Access Compliance Report Public Rights-of-Way (Curb Ramps)

Main Street: ESENCIA_DR Cross Street: MEDANO_ST Location: SE

ADA ID: RPRK211130131619 Ramp Type: Type 1 - Perpendicular Diagonal Initial Pass/Fail: Fail Overall Compliance: No Severity Score: 2

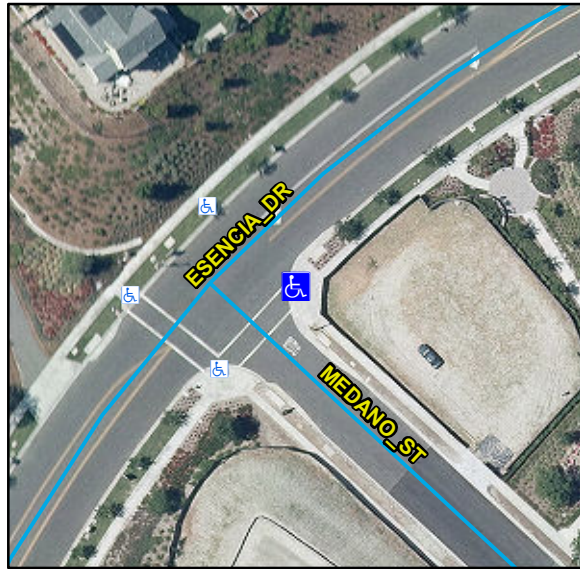
R304.5.3, STD 1115

Remove & Replace Curb Ramp With Two New Directional Ramps or Equivalent.
